Palatka Pulp and Paper Operations
Consumer Products Division
P.O. Box 919
Palatka, FL 32178-0919
(386) 325-2001

Re: Modification of the No. 4 Recovery Boiler, No. 4 Lime Kiln and No. 4 Combination Boiler
Project No. 1070005-038-AC/PSD-FL-380
Response to Request for Additional Information

Figure 1. Startup curves for the Kraft Recovery Furnace at Georgia-Pacific, Palatka Operations

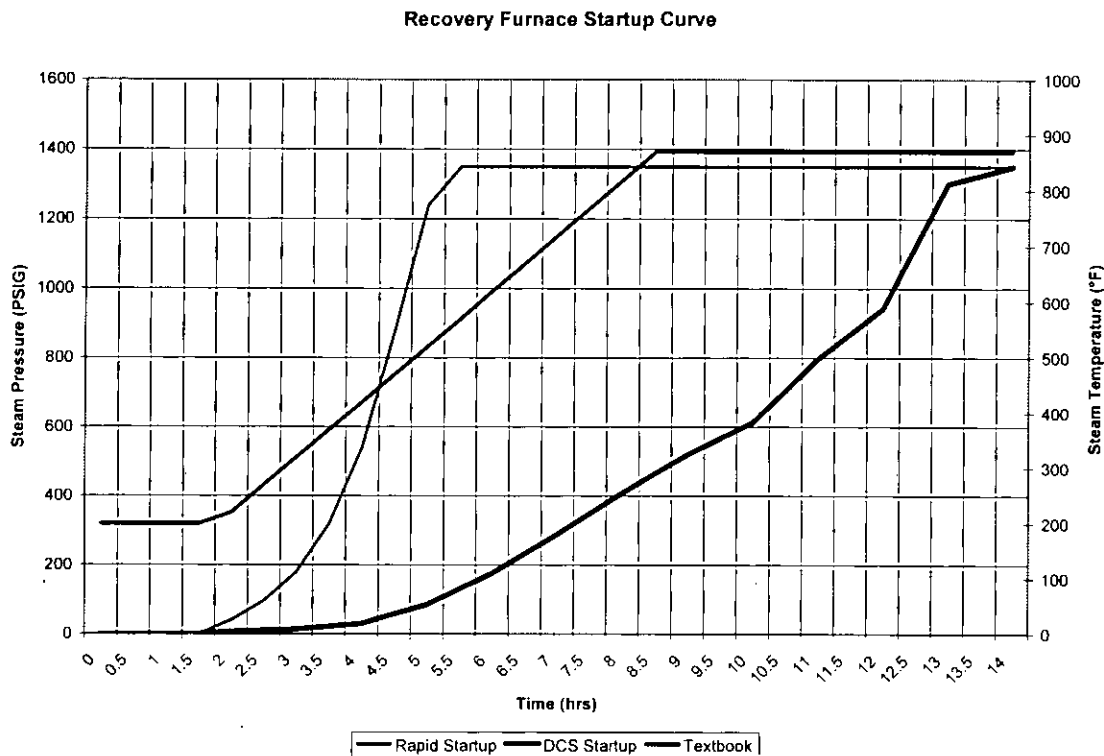
- 2. On November 30th, we received a graph by facsimile labeled "Recovery Boiler 12 Hr. Startup Curve". The graph plots steam pressure (psi) versus time (hours). A statement following the graph indicates that "... it is also a normal startup curve that has been doubled to accommodate an extended boiler outage." Please provide the original graph for a normal startup and identify the conditions for a normal startup. Also, please identify the conditions of a startup after an extended outage and explain the rationale for "doubling" the original graph.**

Reliance on a start up curve to demonstrate the length of a reasonably-necessary startup period for the recovery furnace is not adequate. The startup curve only demonstrates the time necessary to build pressure / temperature in the steam system and to bring the unit online, thus making steam. The full startup ends when black liquor burning is self-sustaining and oil is removed from the furnace.

Figure 1 contains three startup curves for the recovery furnace. The first is the rapid startup curve typically used for the unit. The second is the startup curve in the DCS which is used during a cold startup. The third is the textbook curve which is based on increasing temperature of the steam by 100 degrees Fahrenheit (°F) per hour to control the tube expansion rate. Controlling the startup temperature of the furnace maximizes the cyclic life of the superheater section of the unit. As you are aware, this furnace currently has issues with steam tube cracking that will be addressed by the implementation of this project.

As previously noted, the startup curve in Figure 1 does not represent the end of the startup process for the recovery furnace. After the unit is brought on line with oil, we must continue to burn oil along with the black liquor until a minimum sustainable load is reached on black liquor. At that point, the heat available from the black liquor is sufficient to dry and combust the organics. At that time, the oil burners are gradually removed from service. When all the oil is removed, the unit is considered to be fully out of the startup period.
